SHANCLOON WIND FARM RESPONSE TO THIRD- PARTY SUBMISSIONS

AN COIMISIÚN PLEANÁLA (ACP-323699-25)

P25357-FT-XX-XX-RPT-PL-0001

Figure 1 Extract from Defence Forces Ireland (2014)

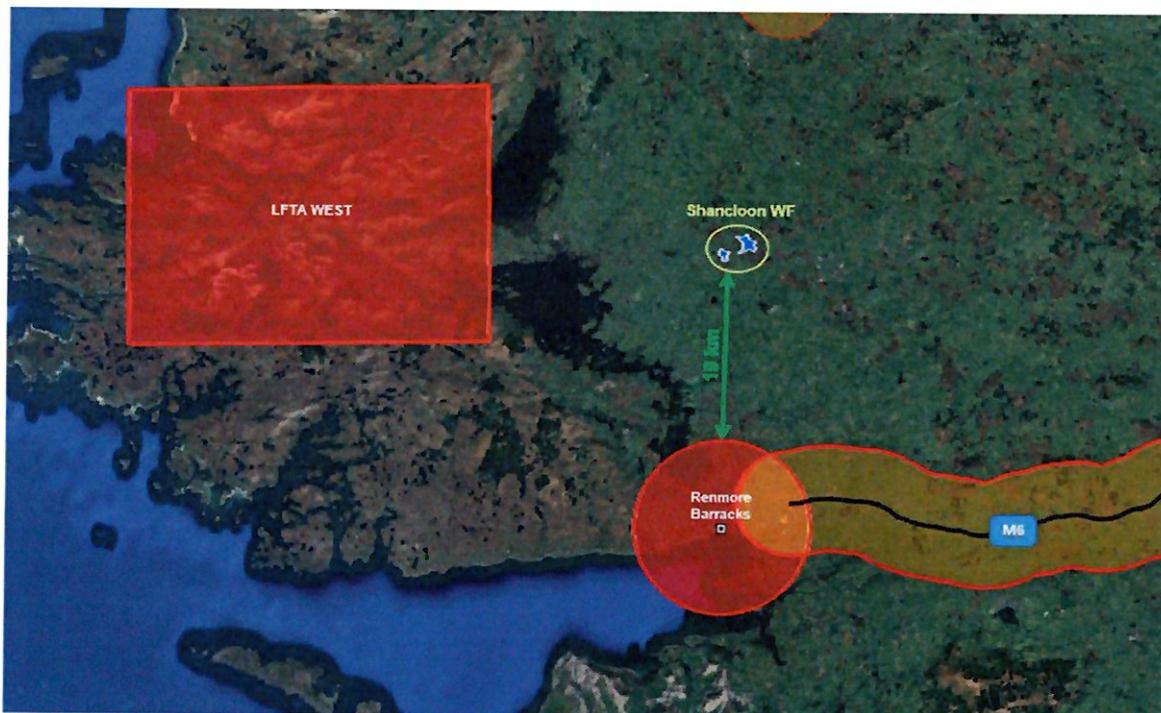
These grid references are located to the west of the N84 road, with L6972; L6945 located towards the Galway coast, and M0745; M0772 located west of Lough Corrib and Lough Mask respectively (see Figure 2 which is an extract from Appendix 17.1 of the EIAR showing the LFTA West area relative to the wind farm). The closest grid reference of the LFTA West (M0772) to the proposed Shancloon Wind Farm is located 31km (16NM) to the northwest, and as such will not affect operations in this area.

Applications or proposals for structures in these areas of a height greater than 45m above ground level at the site of the object must be referred to Irish Air Corps for assessment of potential impact on flight operations.

Figure 3 Cloonbar East Wetland

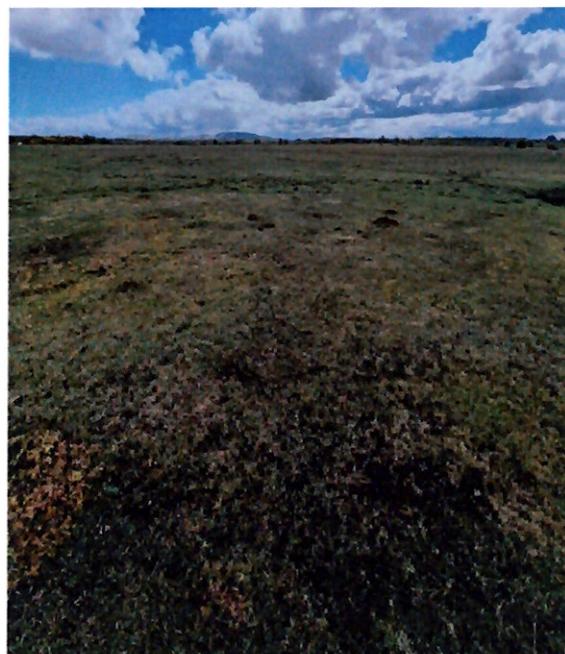
The submission specifically refers to Marsh Fritillary butterfly and the plant species Autumn Gentian as notably not having been recorded within the proposed development boundary. We refer to Figure 3, which is a copy of Plate 9-13 in the Biodiversity chapter of the EIAR which shows the lands proposed for development within Cloonbar East Wetland. These lands have been assessed as not having the suitability to support Marsh Fritillary, and several years of survey have confirmed Autumn Gentian to be absent from the proposed development boundary.

In relation to Autumn Gentian, the submission states that 'this also went unnoticed in the EIA vegetation report for that area'. It is noted that the submission does not provide clarity on where within the c.35ha area of The Commonage these flowers are growing, however it is shown in the EIA that they are not present within the 5ha area of the development boundary within The Commonage. Indeed, as outlined in Section 9.5.4.1 of the Biodiversity Chapter of the EIA, a full botanical survey of the entirety of Cloonbar East Wetland was not carried out, rather botanical survey was focussed to within the zone of influence of the proposed development. While the habitat within the development boundary within Cloonbar East Wetland is suitable for Autumn Gentian in terms of sward height and soil type, the lands were subject to several years of survey and Autumn Gentian was not recorded. Along this vein also the submission states that the Commonage hosts "up to three potential EU annex habitats" but raises concerns that none of them were recorded in the EIA. The proposed development boundary within the Commonage does not host any Annex I habitat as evidenced habitat survey and by geotechnical assessment.
